Project	IEEE 802.16 Broadband Wireless Access Working Group < http://ieee802.org/16 >	
Title	Forcing all SSs to be reset at once	
Date Submitted	2005-07-09	
Source(s)	Yeongmoon Son, Jungje Son, Panyuh Joo Samsung Electronics Co. Ltd.	Voice: +82-31-279-5845 FAX: : +82-31-279-5130 ym1004.son@samsung.com
Re:	IEEE P802.16-2004/Cor1/D3	
Abstract	This contribution proposes the scheme for forcing all SSs to be reset at once	
Purpose	Discuss and adopt this contribution	
Notice	This document has been prepared to assist IEEE 802.16. It is offered as a basis for discussion and is not binding on the contributing individual(s) or organization(s). The material in this document is subject to change in form and content after further study. The contributor(s) reserve(s) the right to add, amend or withdraw material contained herein.	
Release	The contributor grants a free, irrevocable license to the IEEE to incorporate material contained in this contribution, and any modifications thereof, in the creation of an IEEE Standards publication; to copyright in the IEEE's name any IEEE Standards publication even though it may include portions of this contribution; and at the IEEE's sole discretion to permit

Figure 1 – The Operation by Restart Count TLV encoding in DCD message

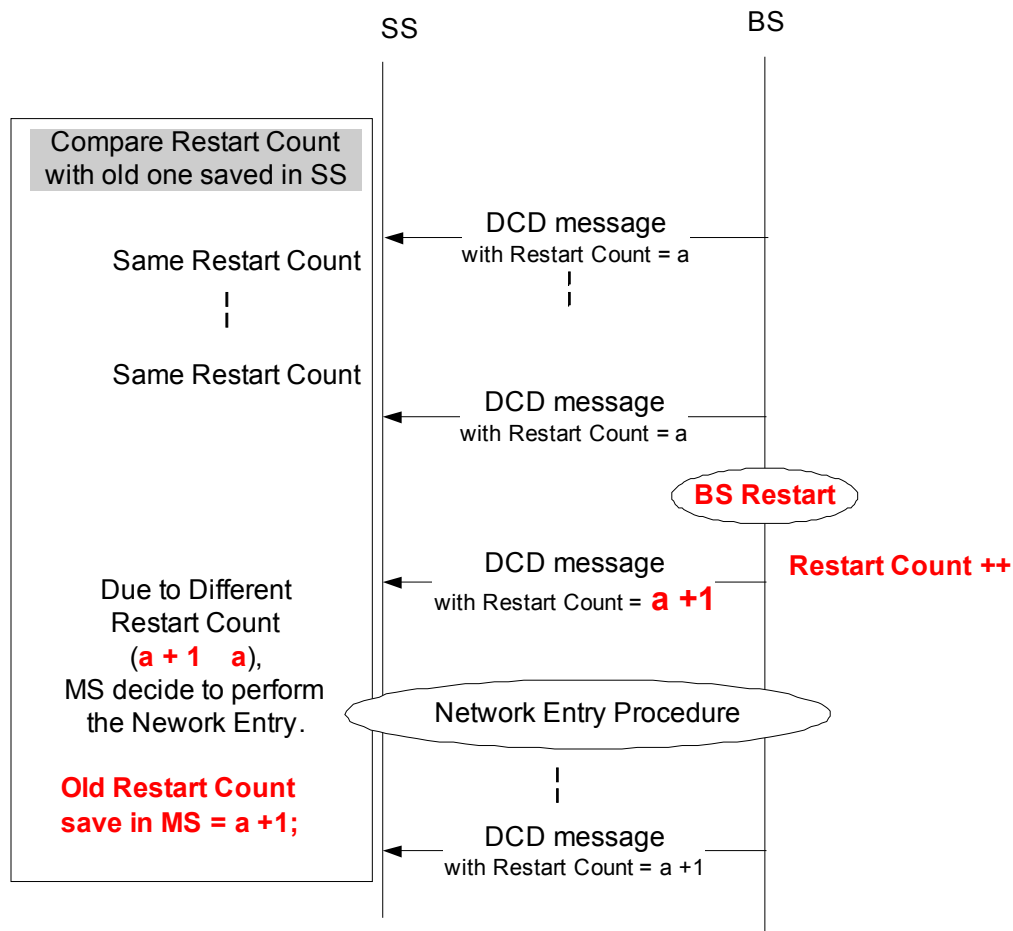
Figure 1 shows the operation by BS Restart Count TLV encoding in DCD message
